URBAN DESIGN COMMITTEE

URBAN DESIGN COMMITTEE STAFF REPORT

APPLICATION NUMBER	Urban Design Record #24093
APPLICATION TYPE	Advisory Review and Final Action
ADDRESS/LOCATION	S 21 st and O St
HEARING DATE	July 9, 2024
ADDITIONAL MEETINGS	-
APPLICANT	Karen Kunc, karen@constellation-studios.net
STAFF CONTACT	Arvind Gopalakrishnan, 402-441-6361, agopalakrishnan@lincoln.ne.gov

CONSTELLATION STUDIOS ADDITION

4.1 Site Development

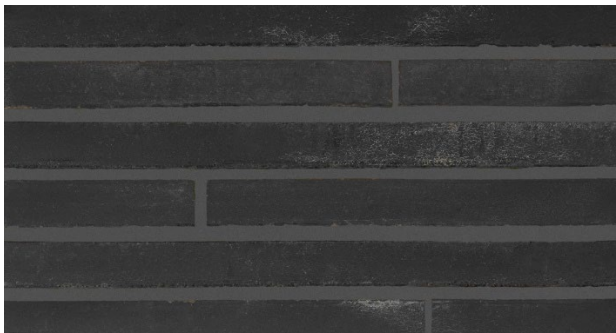
- Downtown Lincoln buildings west of 19th Street and on North 21st Street from O to Q Streets shall be substantially “built-to” their front property lines (and on corner lots, shall be built-to both front property lines).

Compliant

b. Parking structures and lots:

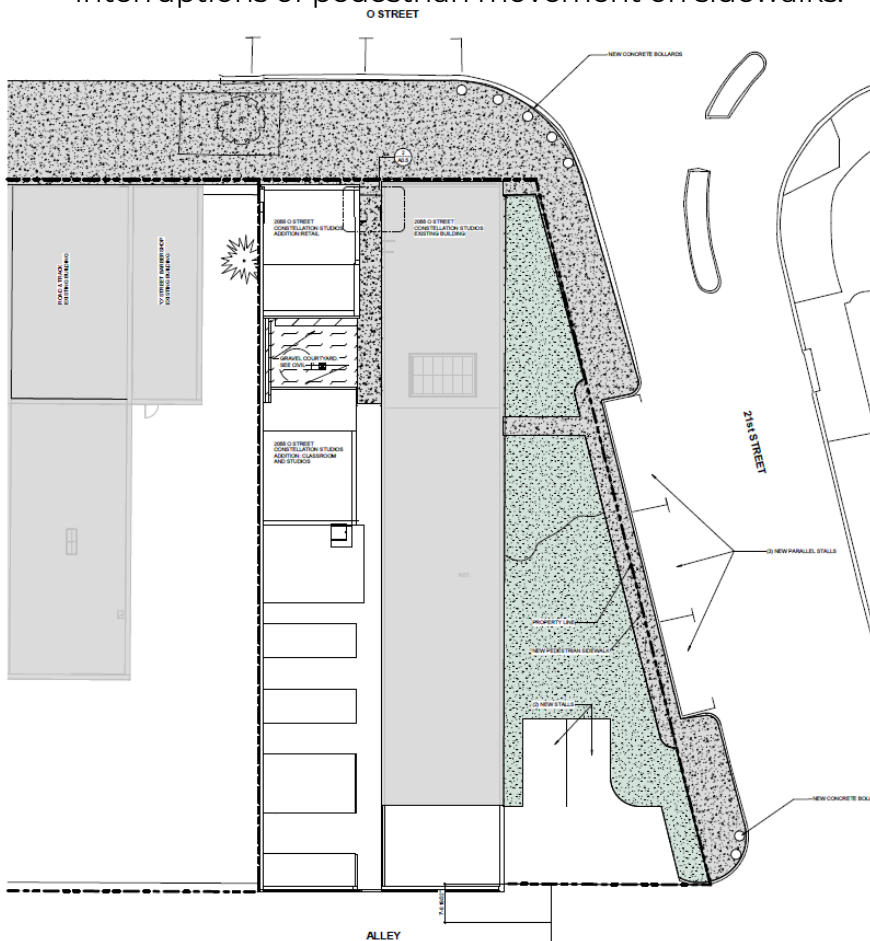
Entrances and exits shall be located and grouped to minimize curb cuts and other interruptions of pedestrian movement on sidewalks. – **Compliant**

The design proposes 4 parking spaces: 2 on the south-east corner of the property, having access from the alley, and 3 street parking spaces along 2nd street. The parking arrangements have been discussed with the LTU department, and they have provided

their approval on the plan. The property is zoned B-4 and therefore doesn't have a minimum parking requirement.

c. Roofs:

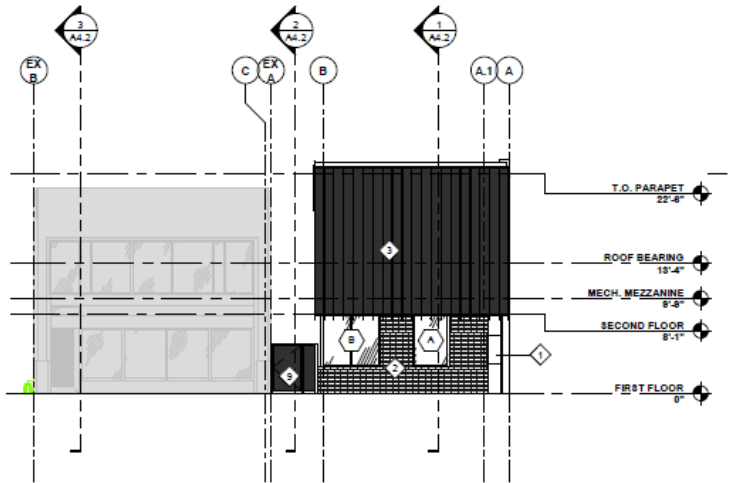
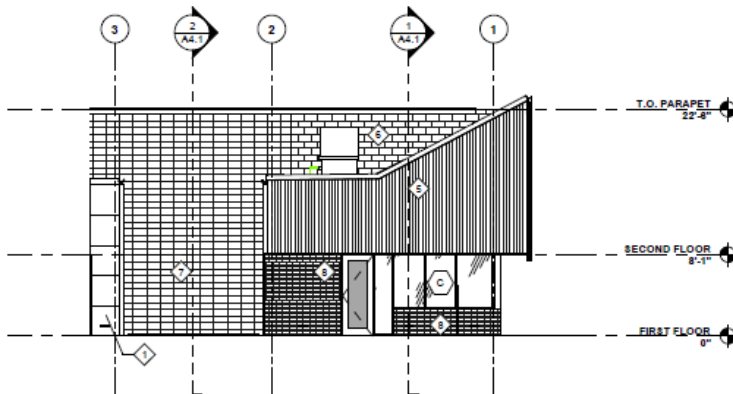
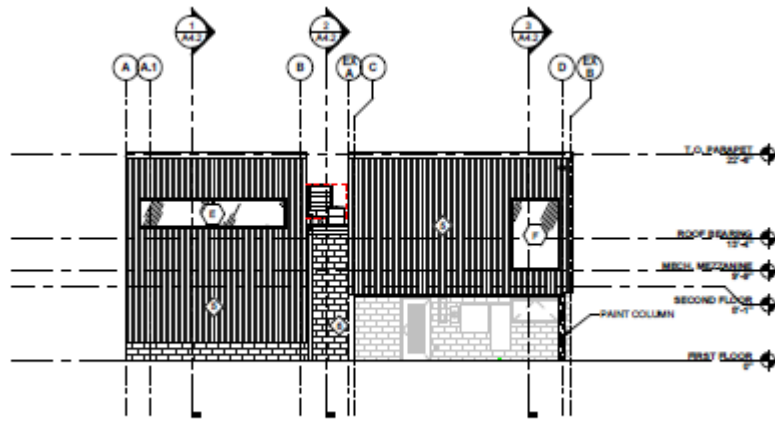
Mechanical equipment on rooftops shall be architecturally screened with materials compatible with the main walls of the building so they are not visible from adjacent streets. – **Compliant**

The mechanical equipment on the roof of the new building will be screened by the existing building, and hence, won't be directly visible from the street.

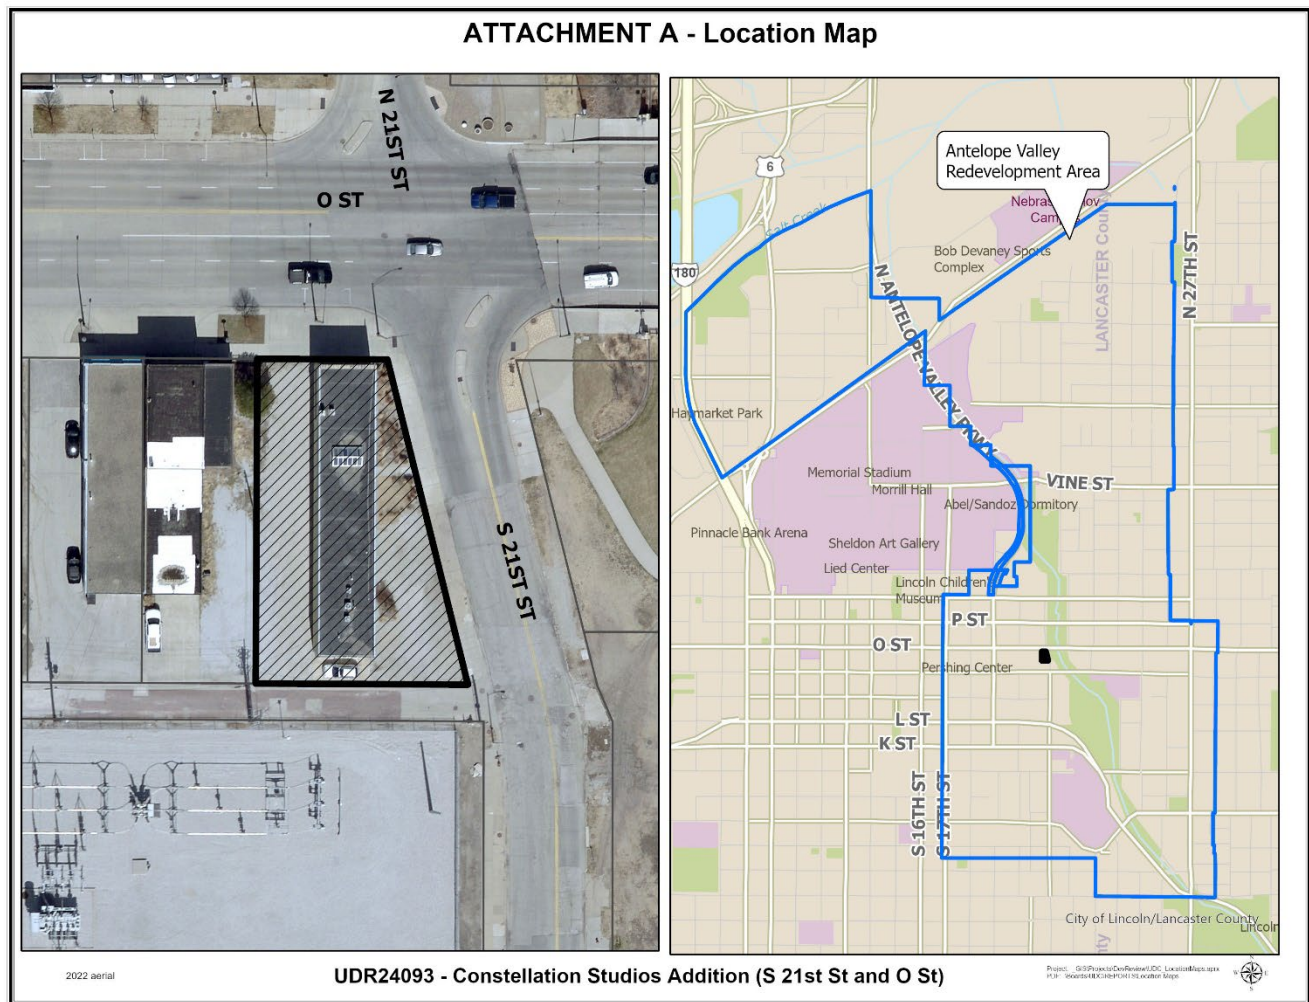
The proposed design is in conformance with the Downtown Design Standards and exceeds the design expectation with interesting design elements such as interior courtyards, an aesthetically pleasing material combination of brick and metal panels and integrating the new design into the existing structure.

Overall, a combination of the existing and the new building creates an interesting elevation that incorporates elements required per the Design Standards, and some additional

features that would bring people's attention to the art studio and also make the intersection safer.

In recent meetings with the design group and City staff, it was determined that bollards along the sidewalk are not an optimal solution to prevent cars turning onto 21st St from encroaching onto the sidewalk. Given the location within the BID, the Downtown Landscape Association (DLA) could help with the installation of a planter as an alternative solution. The planter would serve the same functional purpose while enhancing the aesthetic appeal of the area.

It is crucial to note that the sidewalk must maintain at least 5 feet of uninterrupted space to comply with ADA regulations for accessibility and pedestrian crossing purposes.
